**Walter Sladewski  
(Sub.)**

Sladewski, Walter Subdivision  
Lake Rd. - 4 lots (Hudson Eng.)

**TOWN OF NEW WINDSOR  
PLANNING BOARD  
REVIEW COMMENTS**

**PROJECT NAME:** SLADEWSKI MINOR SUBDIVISION  
**PROJECT LOCATION:** LAKE ROAD (WEST OF JACKSON AVENUE)  
SECTION 54-BLOCK 1-LOT 3.3  
**PROJECT NUMBER:** 92-41  
**DATE:** 13 JANUARY 1993  
**DESCRIPTION:** THE APPLICATION INVOLVES THE SUBDIVISION OF AN  
11.7 +/- ACRE PARCEL INTO FOUR (4) SINGLE-FAMILY  
RESIDENTIAL LOTS. THE APPLICATION WAS PREVIOUSLY  
REVIEWED AT THE 11 NOVEMBER 1992 PLANNING BOARD  
MEETING.

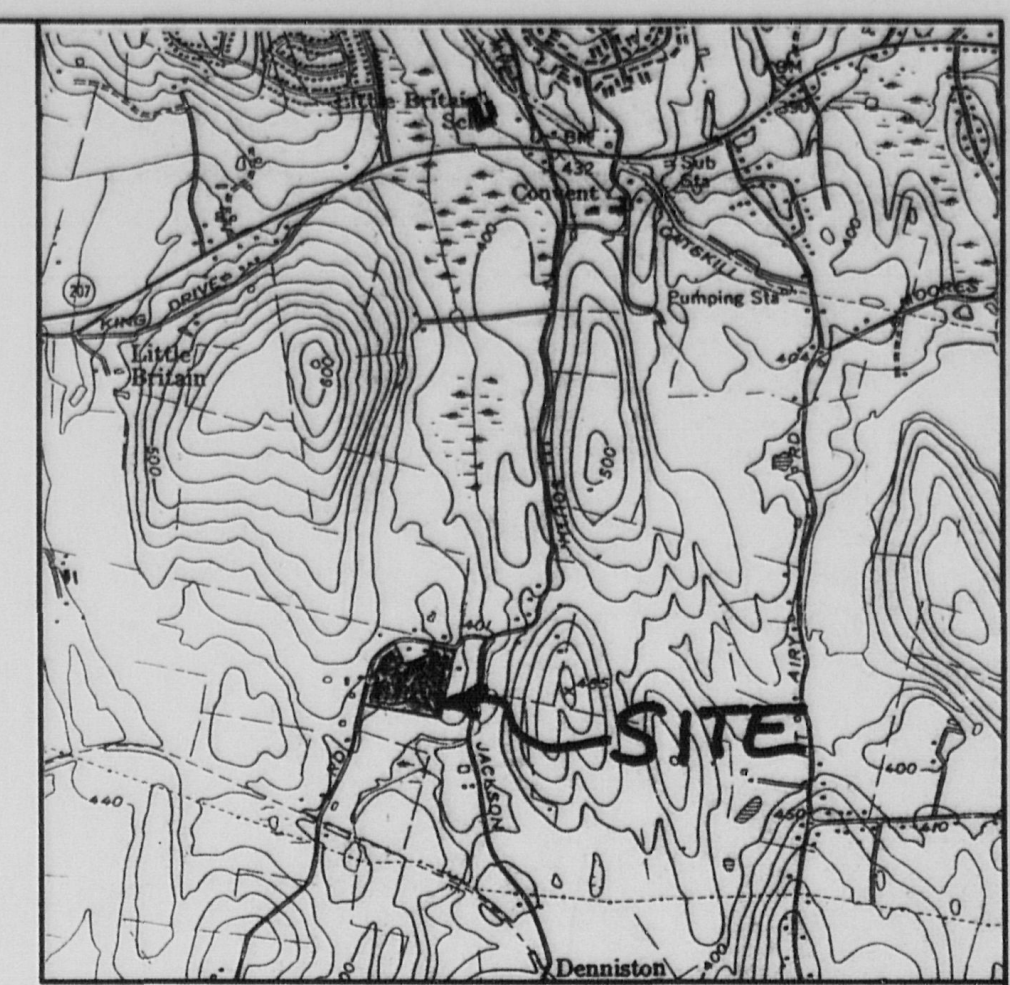
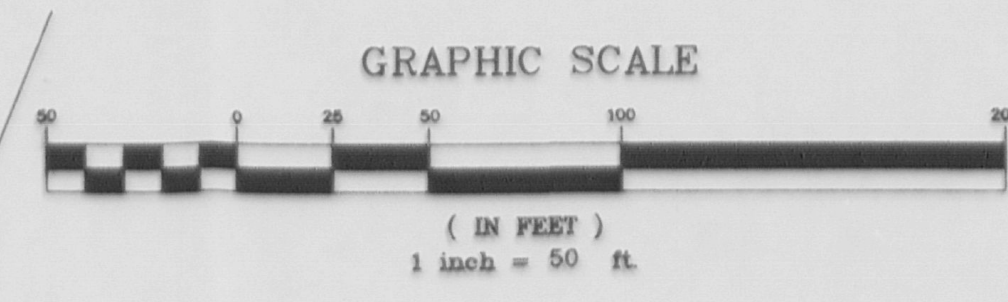
MR. EDSALL: Just for the record, the comments that I had made about the bulk table dates back to 11 November and those two corrections that I requested at that meeting are still not included on the plan. They are not a problem, just a matter of the plan that you ultimately have to stamp should be complete so the bulk tables should have the street frontage requirement and the minimum liveable area both reflected on the bulk table, as of now they are not.

1. No new plan has been received for this application, for this meeting. Based on my most recent comments prepared for the 9 December 1992 meeting, corrections to the bulk tables are still required.

1. My comment sheet dated 11 November 1992 indicated that the lots appeared to comply with the minimum bulk requirements for the R-1 Zone; however, the bulk table was incomplete, missing the minimum requirements for street frontage and minimum livable area. This information has not been added to the resubmitted plan.
2. At the 11 November 1992 meeting, the Planning Board requested that the Applicant meet with the Highway Superintendent with regard to the proposed access to Lake Road. By letter dated 24 November 1992, the Applicant's Engineer indicates that such a meeting was held, with the driveways for Lots 1 and 2 relocated on the plan, per the request of the Highway Superintendent.

MR. PFAU: That has been done.

1. Dimension lines have been added showing separation distances between well and septic systems.
2. All additional existing wells and septic systems within 200 feet of the property line are now shown on the plan. A note has also been added stating that no well or septic systems (other than those shown on plan) are within 200 feet of the property line.
3. No. 2 has been corrected in regards to the tax map number.
4. A meeting was held with the Highway Superintendent and he had requested that the driveways on Lot Nos. 1 and 2 be relocated, which is now displayed on the revised plans.
